SUBJECT: M20V ALTERNATOR WIRING, MOUNTING AND SECURITY
[Chapter 24 - ELECTRICAL POWER]

MODELS/ SN
AFFECTED: Mooney M20V - 33-0001 THRU 33-0018

TIME OF
COMPLIANCE: **Before Next Flight**

Figure SB M20-340-1 - EXISTING ALTERNATOR CABLE ROUTING

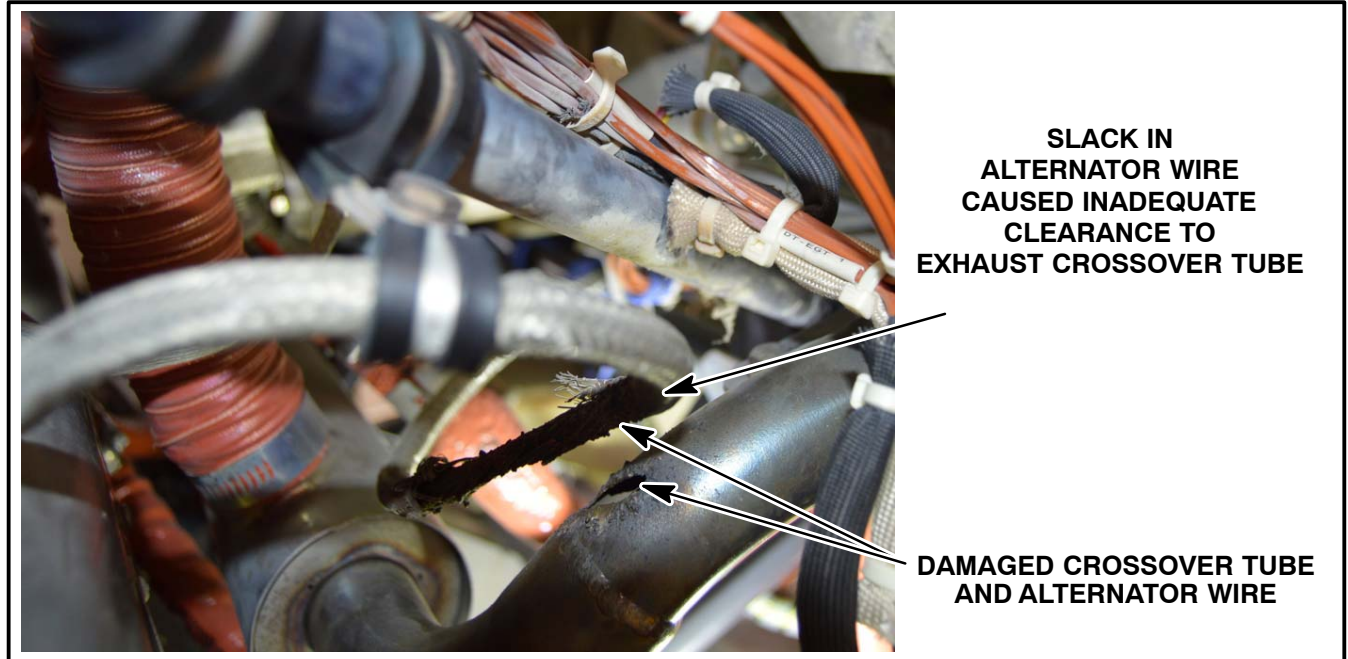
- 1.1. Turn master switch - OFF.
- 1.2. Remove top and bottom cowling, refer to Mooney Service and Maintenance Manual.
- 1.3. Locate alternator cable (refer to Figure SBM20-340-1). Inspect cable for any signs of damage; chafing, cracks in shielding, burnt spots, etc., if cable is damaged, contact MOONEY TECHNICAL SUPPORT support@mooney.com for a replacement cable.

- 1.4. Locate RH exhaust crossover tube. Inspect for damage; holes, cracks, etc., if damaged contact MOONEY TECHNICAL SUPPORT support@mooney.com for a replacement crossover tube, refer to Figure SBM20-340-1.

Figure SB M20-340-2 - ALTERNATOR CABLE ROUTING LOCATION (RH ENGINE MOUNT)

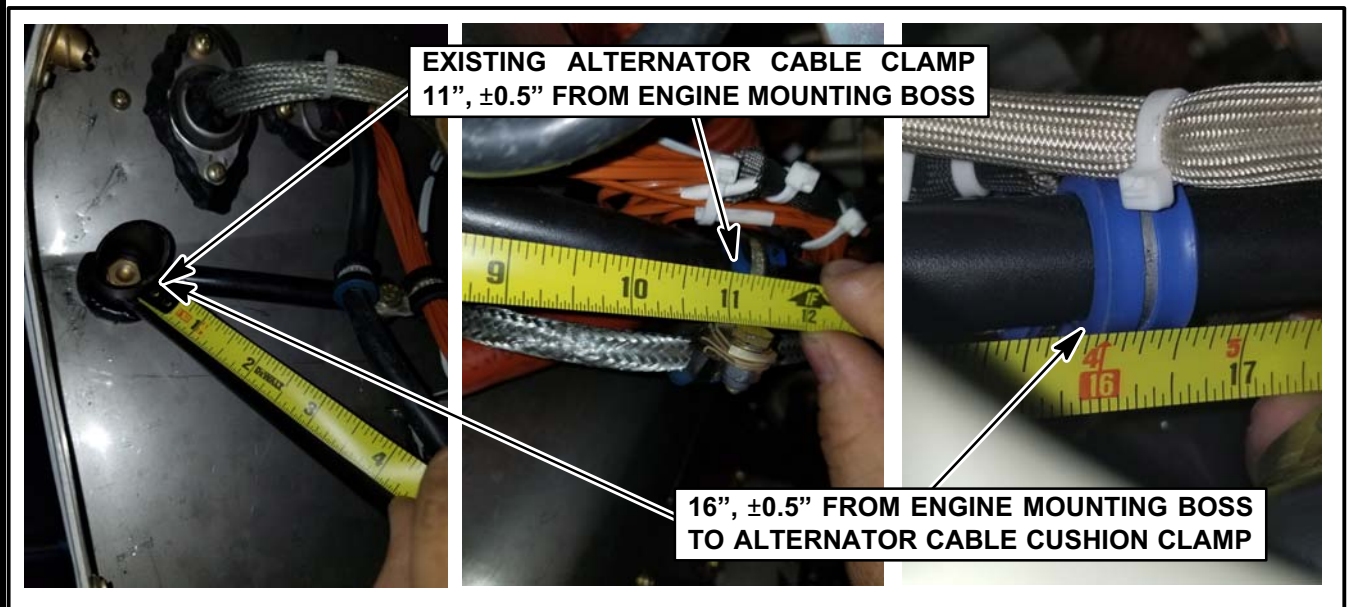
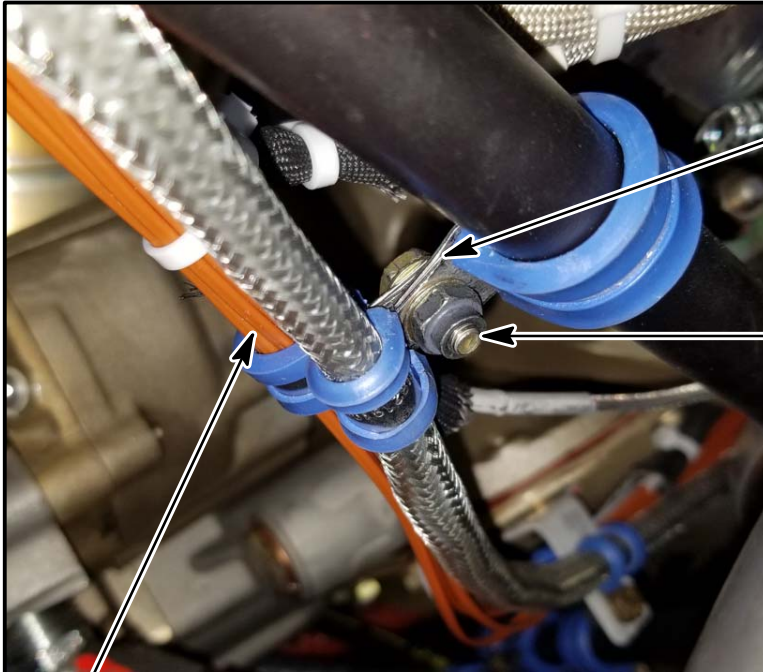
- 1.5. Assure the existing alternator cable clamp is located on the RH engine mount to as indicated in Figure SBM20-340-2 (center). The clamp should be located at the indicated location, approximately 11" (11" \pm 0.5") from the RH engine mount mounting boss.

- 1.6. From RH engine mount mounting boss, measure along engine mount tube approx 16" (16" \pm 0.5") to locate cushion clamps mounting alternator field sensor and cylinder thermocouple wires to engine mount, refer to Figure SBM20-340-2.
